RE: Fidelity Response to BLM Preliminary Alternatives, West Fertilizer Exploratory Area

Fidelity's West Fertilizer 16-Pad Oil and Gas Project
Preliminary Alternatives

Preliminary Alternatives

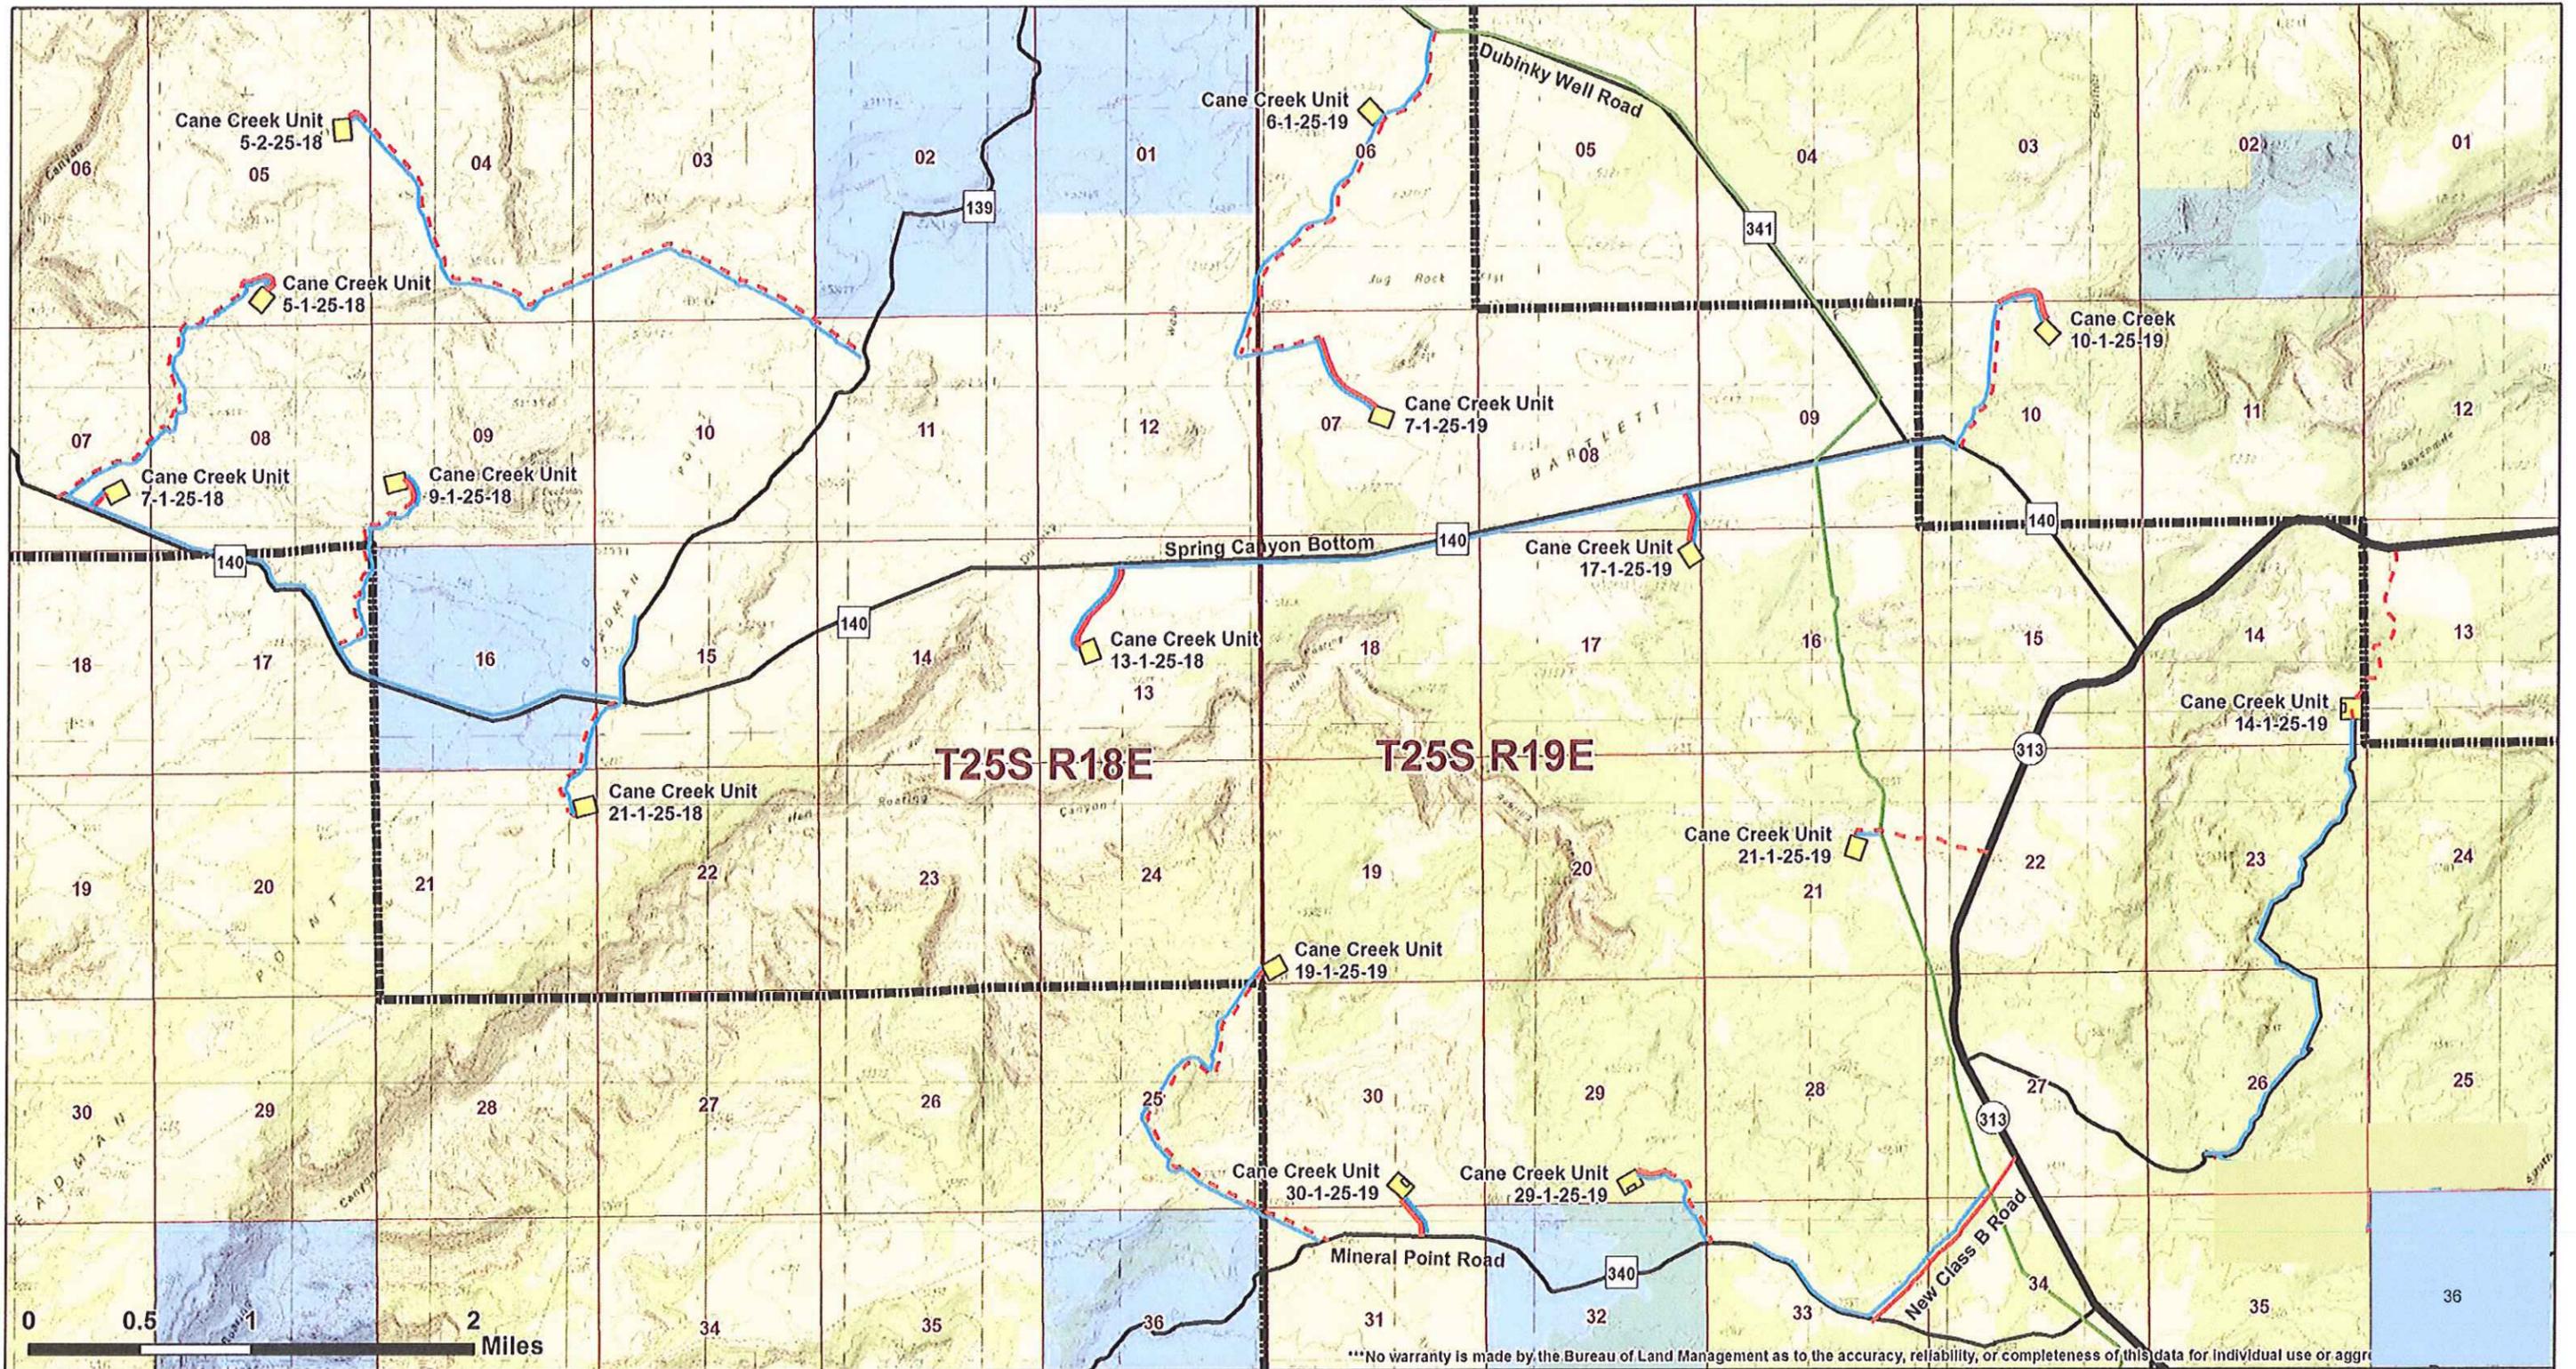
It is BLM's obligation that only "reasonable" alternatives be considered; per H-1790- NEPA Handbook "Reasonable alternatives include those that are *practical or feasible* from the technical and economic standpoint and using common sense,..." Fidelity strongly maintains that the preliminary alternative (Map 2) is technically impractical because it totally discounts the nine years of professional effort by a dedicated staff supporting the choice of the proposed well pad locations; uneconomic because the alternate locations provide no reasoned technical basis for likely production success; and wholly contrary to the intent of the Mineral Leasing Act (MLA) and issuance of valid leases. The MLA was enacted by Congress to promote the orderly development of mineral resources and to provide the public with a reasonable return. Given the development purpose of the MLA, the imposition of significant surface-use restrictions by replacing the proposed well pad locations with entirely and substantially different well pad locations violates Congress' intent in enacting the MLA. The BLM must administer the MLA so as to provide some incentive for and to promote the development of oil and gas deposits in its leased federal lands through private enterprise. Consideration of the alternative presented by the Moab BLM field office as viable removes the possibility of successful production in an area that has shown limited and unpredictable production success in the past. The alternative removes the incentive for private development of valid leases and, in practice, constitutes a denial of the proposed development of the mineral resource.

An evaluation of each of BLM's preliminary alternative well site proposals (Map 2) is provided below. Again, generalized comments provided above should be considered along with comments provided for each alternate well site. Specific information for each relocated pad was provided in BLM's Preliminary Alternatives Tables 1 and 2.

CCU 5-1, 5-2 & 9-1 (1 & 2)- Co-location of three proposed wells to a single pad location would eliminate Fidelity's directional strategy for multiple wells from each of the three Fidelity proposed well pads targeting a specific fracture orientation. The horizontal distance required to reach Fidelity's geologic targets from this centralized location greatly exceed technical and economic limits. BLM's proposal of a multi-pad offsite tank-battery facility approximately 4-miles to the East would require the uneconomic addition of oil gathering pipeline costs and line heaters every 100-200 feet (or between 100-200 heating units) for long-term oil collection.

CCU 21-1-25-18 (1)- BLM's preliminary alternative recommends a slight move of the well location to presumably address visual impacts. Although Fidelity may consider a slight, justifiable move of this location, there has been no substantiation or rationale provided by BLM. The intent to recognize the West Fertilizer area as VRM Class II is not substantiated and would not provide justification in itself to affect Fidelity's proposed pad location.

CCU 21-1-25-18 (2 & 3)- BLM recommends a pad relocation approximately 1-mile to the west which would eliminate Fidelity's directional strategy for multiple wells from this location targeting specific geologic structure and fracture orientations to the east and south. The horizontal distance required to reach Fidelity's geologic targets from this revised location exceed technical and economic limits. BLM's intent to avoid unsubstantiated WC areas to the east is unjustified and unwarranted considering BLM's decision not to manage WC areas for preservation of this resource. Fidelity has committed significant time, effort and cost in permitting this BLM verified location.

CCU 6-1 & 7-1 - Per BLM's preliminary alternative, pad relocation of the CCU 6-1 approximately 1 ½-miles to the southwest (independently) or co-located with the CCU 7-1 approximately 1 ½-miles to the south would eliminate Fidelity's directional strategy for multiple wells from Fidelity's proposed CCU 6-1 location targeting specific geologic structure and fracture orientations to the northwest, southwest and southeast. The horizontal distance required to reach Fidelity's geologic targets from the revised location exceed technical and economic limits and drilling direction is contrary to Fidelity-determined fracture patterns.

BLM's proposal to relocate the CCU 7-1 within an abandoned well pad approximately 1/4-mile to the northwest has not been justified. Fidelity's proposed location was chosen to eliminate any line-of-site view to the Jug Rock rock-art area. Use of an existing disturbance may be appropriate and Fidelity may be open to discuss moving this location should BLM provide rational and justification for the move. Regardless, Fidelity has committed significant time, effort and cost in permitting this BLM verified location.

CCU 13-1-25-18- Pad relocation approximately 1-mile to the north would eliminate Fidelity's directional strategy for multiple wells from this location targeting specific geologic structure and fracture orientations to the southwest and northwest. The horizontal distance required to reach Fidelity's geologic targets from this revised location exceed technical and economic limits. BLM's intent to avoid unsubstantiated WC areas south of Spring Canyon Road is unjustified and unwarranted considering BLM's decision not to manage WC areas for preservation of this resource. Fidelity has committed significant time, effort and cost in permitting this BLM verified location.

CCU 17-1-25-19- BLM's preliminary alternative recommends a slight move of the well location approximately 100-feet to the northeast. Although Fidelity may consider a justifiable move of this location, there has been no substantiation or rational provided by BLM.

CCU 21-1-25-19- BLM's preliminary alternative recommends a move of the well location approximately 600-feet to the southwest. Fidelity's proposed location was chosen after several moves to the west by BLM's resource team during several BLM field onsites (March 2014 and August 2015). The relocation by BLM was to reduce visual impacts to Highway 313 (a VRM Class II buffer) and was field verified by BLM. Also, the VRM simulation of this well pad developed by a company accomplished in professional visual simulations strongly demonstrates minimal visual impacts from the current pad location. Fidelity may be open to discuss moving this location should BLM provide rational and justification for the move.

CCU 14-1-25-19 (1 & 2)- Pad relocation approximately ½- mile to the west or 1 ½- mile to the southwest would eliminate Fidelity's directional strategy for multiple wells from this location targeting specific geologic structure and fracture orientations to the west and northwest. The horizontal distance required to reach Fidelity's geologic targets from this revised location exceed technical and economic limits.

CCU 25-1-25-19- BLM's preliminary alternative recommends a move of the well location approximately ¼-mile to the northeast. Fidelity's proposed location was chosen after several location adjustments by BLM's resource team during several BLM field onsites (June 2012, September 2012, March 2014 and August 2014). The preliminary alternative relocation by BLM is apparently to reduce visual impacts from Gemini Bridges Road. Fidelity's VRM simulation of the location, developed by a company accomplished in professional visual simulations, strongly demonstrates minimal visual impacts to Gemini Bridges from the current pad location. Pad relocation would compromise Fidelity's directional strategy for multiple wells from this location targeting specific geologic structure and fracture orientations to the west, northwest and southeast.

BLM's proposal of a multi-pad offsite tank-battery facility located on the 26 pad approximately two miles to the west would require the uneconomic addition of oil gathering pipeline costs and line heaters every 100-200 feet (or between 50-100 heating units) for long-term oil collection.

CCU 19-1 & 30-1 - Per BLM's preliminary alternative, pad relocation of the CCU 19-1 approximately ½-mile to the east would eliminate Fidelity's directional strategy for multiple wells from Fidelity's proposed location targeting specific geologic structure and fracture orientations to the northwest and northeast. BLM's intent to avoid unsubstantiated WC areas south of Hell Roaring Canyon is unjustified and unwarranted considering BLM's decision not to manage WC areas for preservation of this resource. Further, the horizontal distance required to reach Fidelity's geologic targets from the revised location exceed technical and economic limits and the drilling direction is contrary to Fidelity-determined fracture patterns. Access road construction to the alternate location would be extremely expensive, cause unnecessary disturbance and encroach on buffer offsets from the Hell Roaring Canyon rim and wildlife habitat buffers. Fidelity's proposed location utilizes existing 2-track disturbance for road access.

BLM also proposes an alternative with a slight move of the CCU 19-1 pad approximately 150 feet to the north and co-locating the CCU 30-1 well on the same pad. Although Fidelity may consider a justifiable move of this location, there has been no substantiation or rationale provided by BLM. Relocation of the CCU 30-1 pad would eliminate Fidelity's directional strategy for multiple wells from Fidelity's proposed location targeting specific geologic structure and fracture orientations to the northwest and northeast. The horizontal distance required to reach Fidelity's geologic targets from the revised location exceed technical and economic limits and drilling direction is contrary to Fidelity-determined fracture patterns.

CCU 29-1 & 30-1 - Per BLM's preliminary alternative, pad relocation of the CCU 19-1 co-located with the CCU 30-1 would eliminate Fidelity's directional strategy for multiple wells from both of the Fidelity proposed locations targeting specific geologic structure and fracture orientations. The horizontal distance required to reach Fidelity's geologic targets from the revised location exceed technical and economic limits and drilling direction is contrary to Fidelity-determined fracture patterns. BLM's intent to avoid unsubstantiated WC areas south of Hell Roaring Canyon is unjustified and unwarranted considering BLM's decision not to manage WC areas for preservation of this resource.

West Fertilizer 15 Pad Oil & Gas Project Map 1 Grand County, Utah

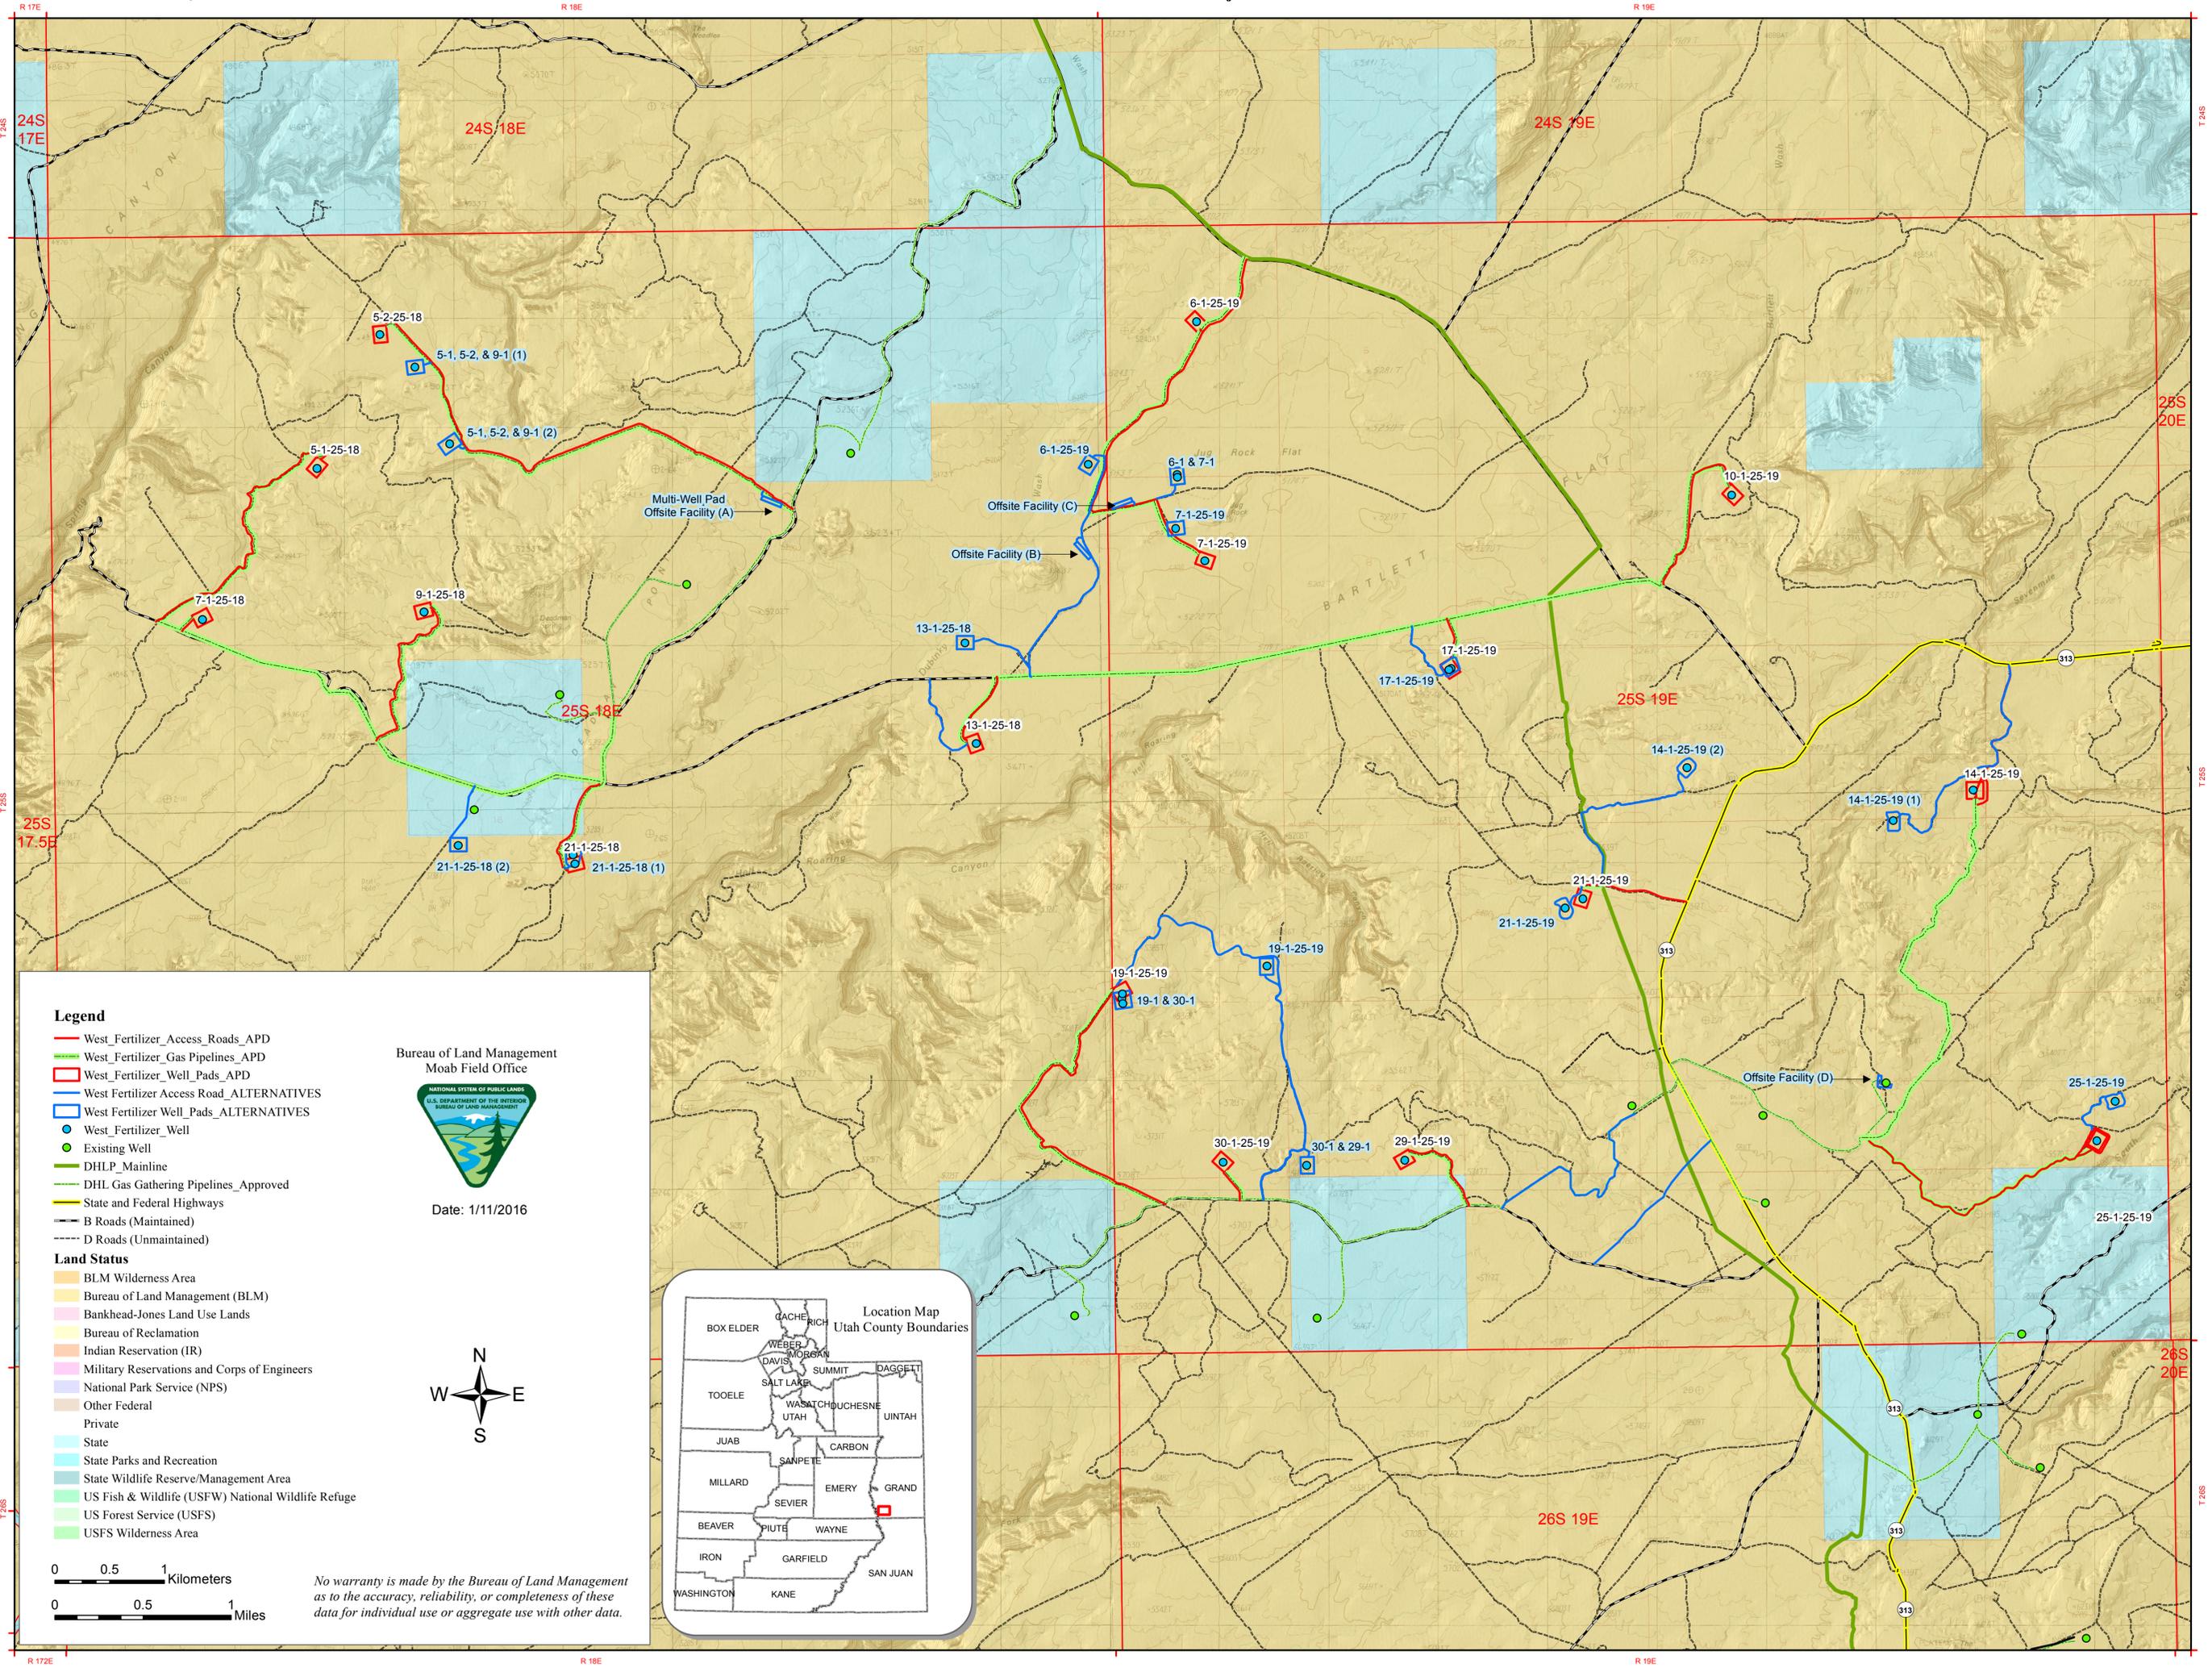
As you are aware, Fidelity has provided a Master Exploration Plan and formal proposed action for its exploration and development of the West Fertilizer area in and near its Cane Creek Unit. The proposal requests to construct 15 new well pads plus an additional 16th pad near the West Fertilizer area (Map1). The exploratory project would initially disturb approximately 190 acres over a 32,000 acre area (an approximate 0.6% disturbance footprint) to advance up to 48 horizontal wells. The wells are strategically placed on optimized multi-well pad locations to target multiple geologic regimes and fracture orientation models within the structurally complex Paradox Basin.
